MU B Ground Water Submittal

RE: Source Material License SUA-1548, Docket No. 40-8964, Mine Unit B Ground Water
Restoration Submittal

RE: Permit No. 603- Highland Uranium Project
Mine Unit-B Ground Water Restoration Report

**Mine Unit B Ground Water Restoration Report
Smith Ranch - Highland Uranium Project**

Figure 6: MP-14 Arsenic, Iron and Uranium Concentrations

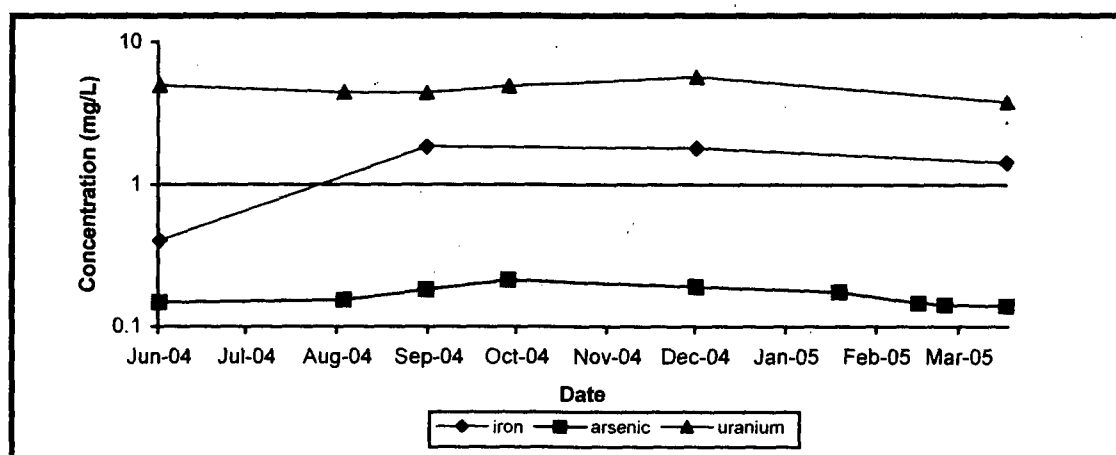
The elevated arsenic level is a concern for the success of the restoration effort within the wellfield, especially in the MP14, 21 and MP 22 well areas. The arsenic concentration may decline as the biogeochemical reaction progresses to equilibrate to acceptable levels during stability. The restoration process lasted over 13 years, which would not represent proper application of best practicable technology. If the arsenic levels do not stabilize to suitable levels, PRI may be required to perform additional restoration of specific wells as specified in Section 4.3.4 of the Reclamation Plan. *

The kinetics of this process is relatively slow, however there is evidence from the Production Zone ground water data collected during the Stability Period that the arsenic concentration is decreasing. The arsenic concentration in Well MP-30 decreased by half during the Stability Period from 0.016 mg/L to 0.008 mg/L. Also, since the dissolution of the iron hydroxides has ceased, arsenic will no longer be coming into solution. An example of this trend is Well MP-14, which is one of the wells of concern. Arsenic, iron and uranium concentrations are decreasing in this well (Figure 6). Copies of the original laboratory reports are included in Appendix A. The entire mine unit is predicted to react similarly since reducing conditions are present throughout.

The mine unit average arsenic concentration remained below the Class II and Class III standards during the Stability Period. PRI believes that any further active restoration to decrease the arsenic concentration is not needed since the conditions already exist within the Production Zone that will cause the arsenic to precipitate from solution.

Figure 7: Location of EO8

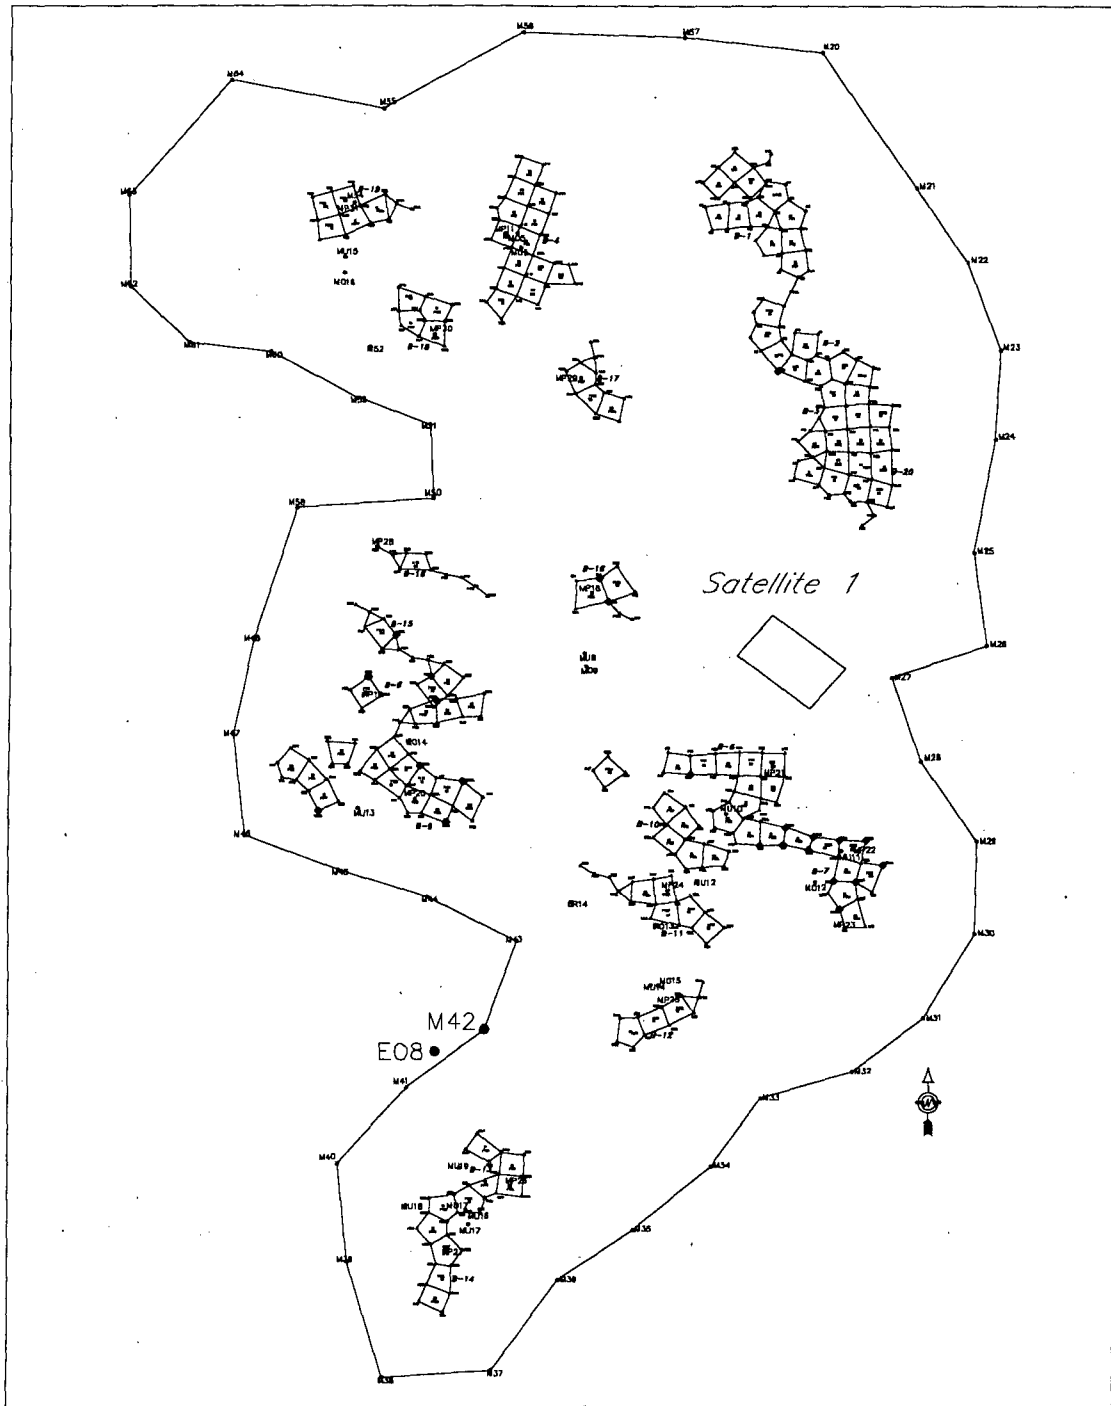
1. The text should discuss the individual parameter results for wells exceeding the baseline average concentration in the wellfield.
2. Wells M-38 and M-48 should be sampled.
3. Four monitor wells exceed baseline and class of use. PRI should restore these wells to meet the statutory requirements.
4. There were no graphs provided showing the water quality improvement during each stage of restoration. Please provide graphs showing water quality improvement.

The four perimeter non-mineralized Production Zone monitor wells that are referred to in this comment are Wells M-42, M-43, M-44 and M-45.

The pre-mining ground water classification for Well M-42 is Class IV (A) since all parameters met Class I Standards, except for the radium 226 concentration, which exceeded the Class I Use Suitability Standard of 5 pCi/L. PRI considers this well to be restored as required by Section 4.2.1 of the Reclamation Plan, since all parameters have been restored "to the baseline condition" for this well.

Figure B-1, Time-Concentration Plots of Monitor Wells MP-11 to MP-16, May 2004

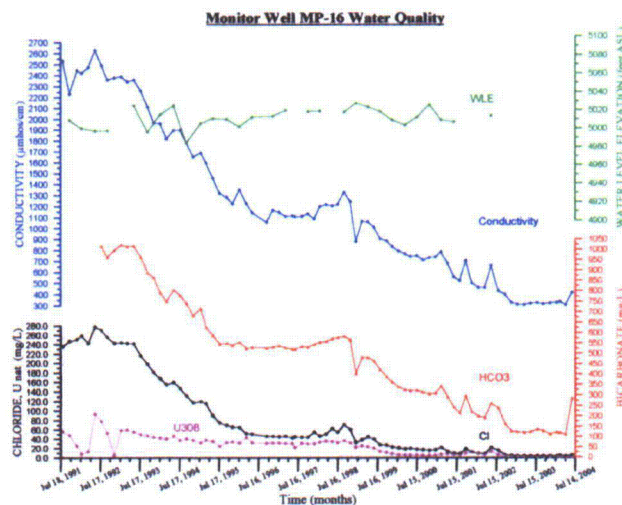
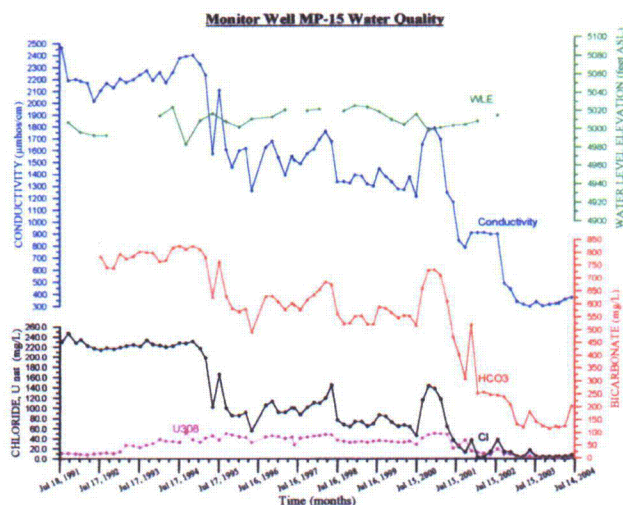
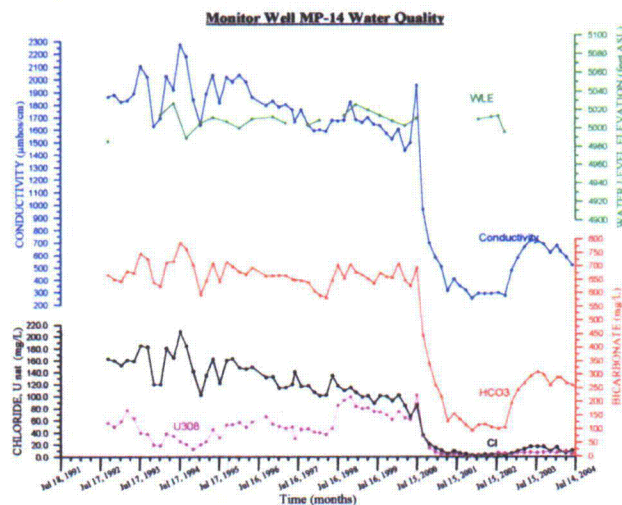
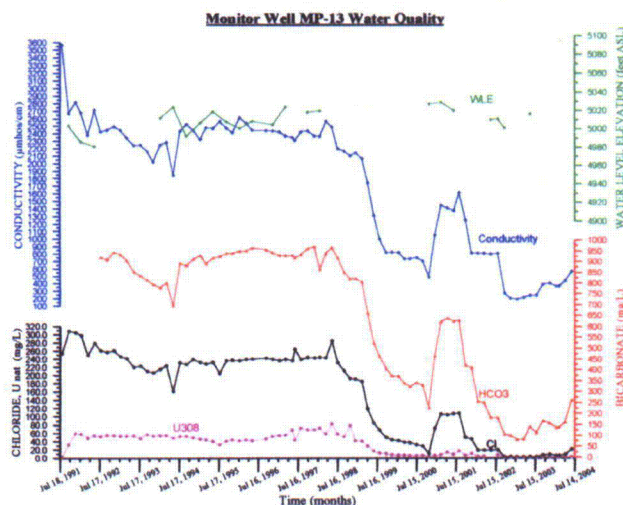
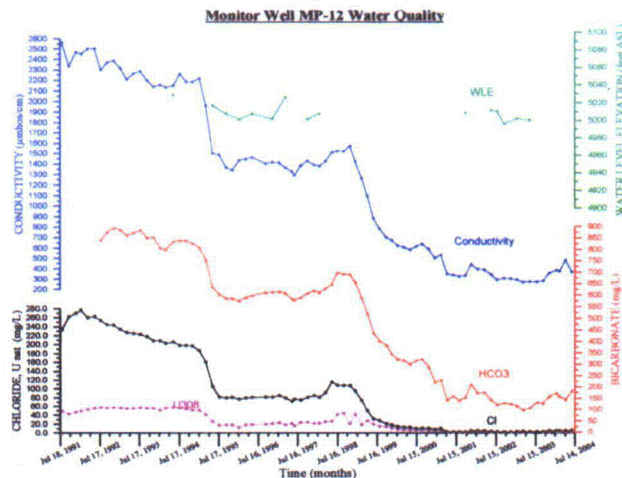
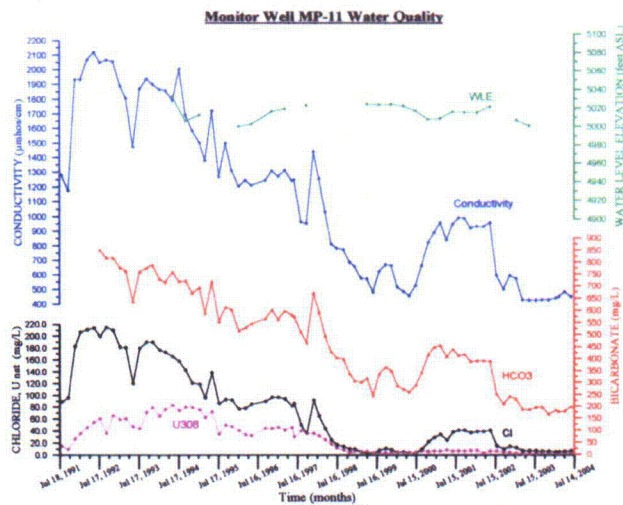
There were no graphs provided showing the water quality improvement during each stage of restoration. Please provide graphs showing water quality improvement.

Table 9 lists the time frame for each stage of restoration, so that ground water quality improvement can be noted during each stage. Ground water quality graphs of the MP-Wells sampled in Mine Unit B during restoration are provided as Figure B-1 through Figure B-4.

Arsenic Stability and Post-Stability Data

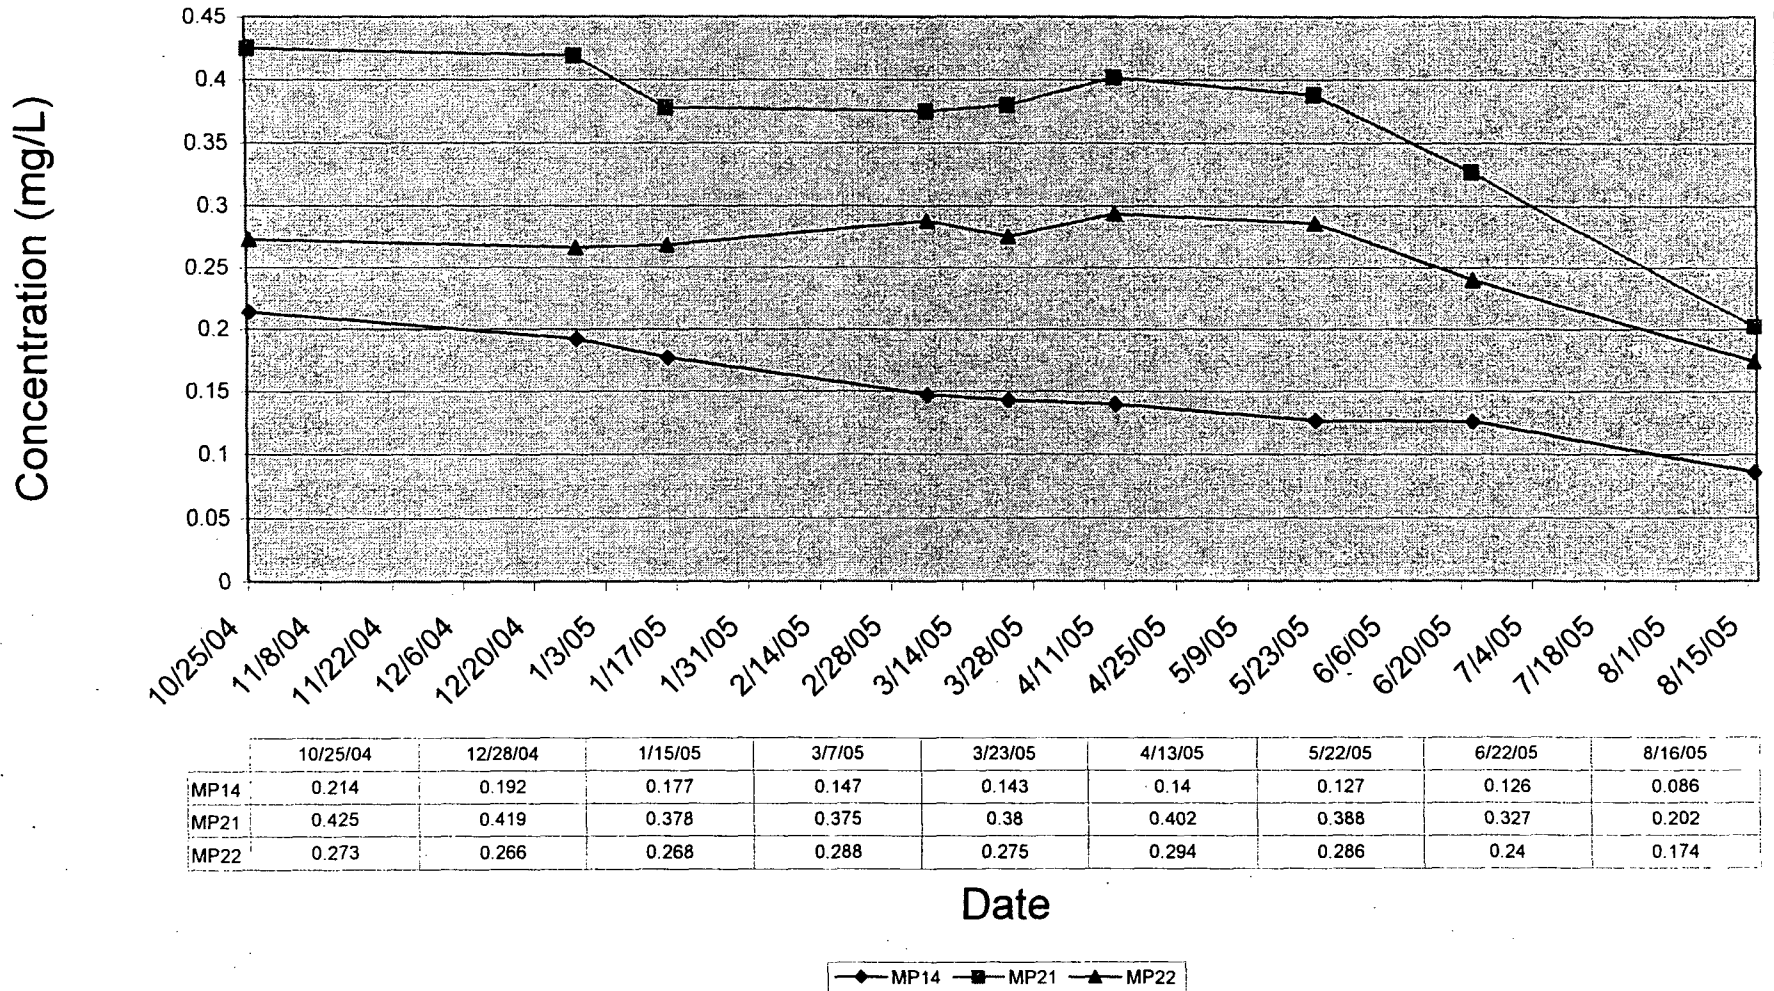
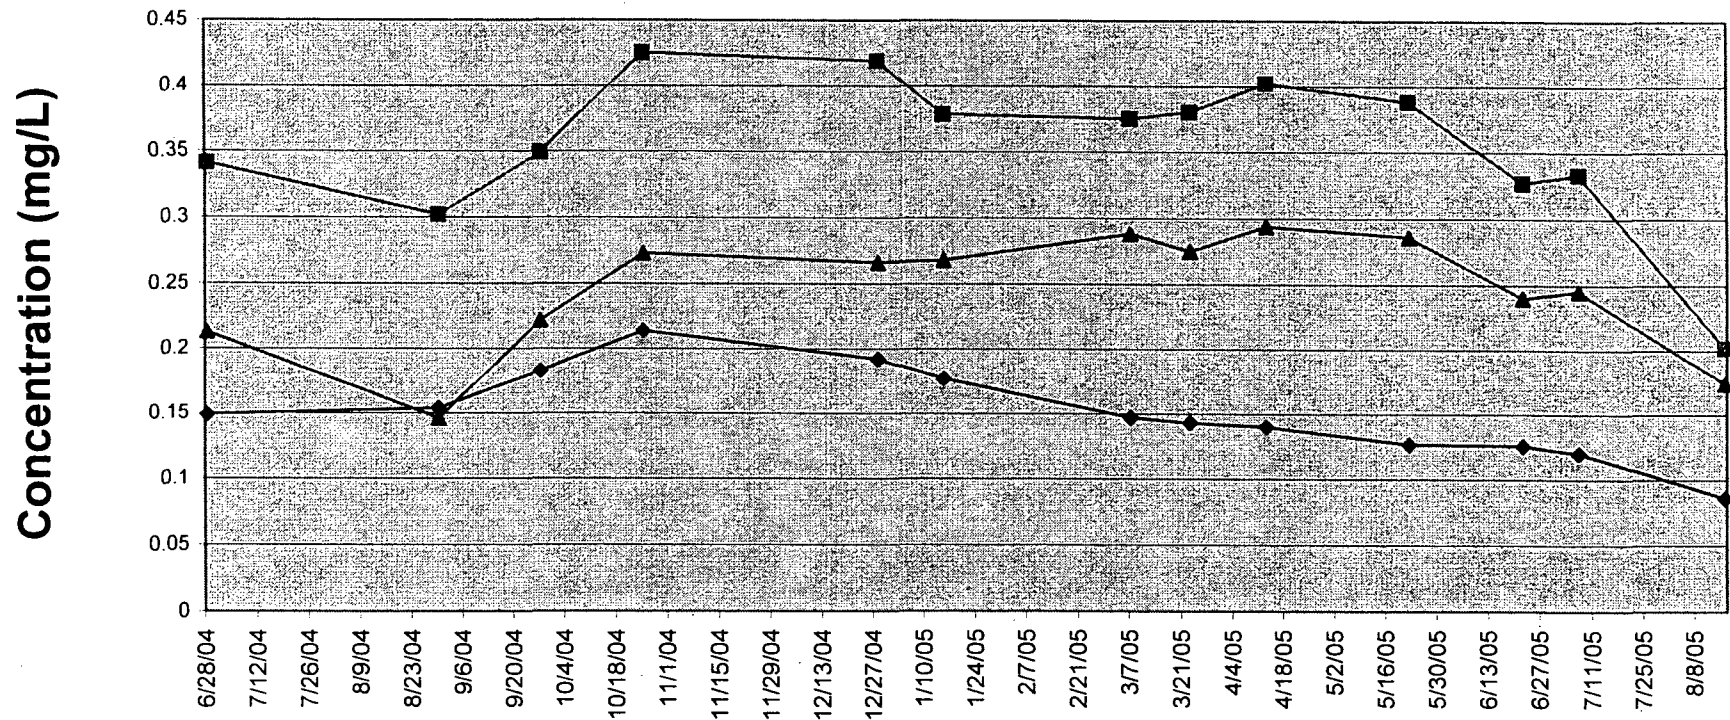
Following this discussion, Mr. Ingle requested that PRI provide additional ground water quality data for the three MP-Wells in question. Therefore, please find enclosed with this correspondence, the analyses of additional ground water samples collected from Wells MP-14, MP-21, and MP-22 on May 22, 2005. Mr. Ingle will use this data set to perform additional statistical analyses, the results of which will be discussed in a conference call between the parties involved in the original meeting, the week of June 13, 2005.

A review of the data indicates that the arsenic concentration trends at these wells are strongly decreasing. These decreasing trends were not unexpected as they fit the conceptual model of the post restoration geochemistry as proposed by PRI in the "Mine Unit B Ground Water Stability Report" submitted to the LQD on May 5, 2005, "Appendix B: Response to LQD Staff Comments" pages B-3 through B-6. A copy of this discussion is enclosed and it begins with the discussion of iron concentrations on page B-3. As discussed, the decreasing arsenic concentrations at these wells are most likely due to the reducing conditions established within the MU-B Production Zone during active restoration and these trends are expected to continue as insoluble arsenic minerals are formed. Also, it should be noted, that during a meeting between

Also, please note that with the most recent sample results (August 16, 2005), the average arsenic ground water concentration for MU-B is less than the Class of Use Standard of 0.05 mg/L. As stated in Section 4.1 of the Reclamation Plan, ground water restoration success is based on the average ground water concentration of the MP-Wells. Since the average mine unit arsenic concentration is below the Class IV (A) Standard and since the arsenic concentrations at MP-Wells 14, 21 and 22 are exhibiting strongly decreasing trends, PRI believes that the LQDs concern about the arsenic concentration in MU-B has been addressed.
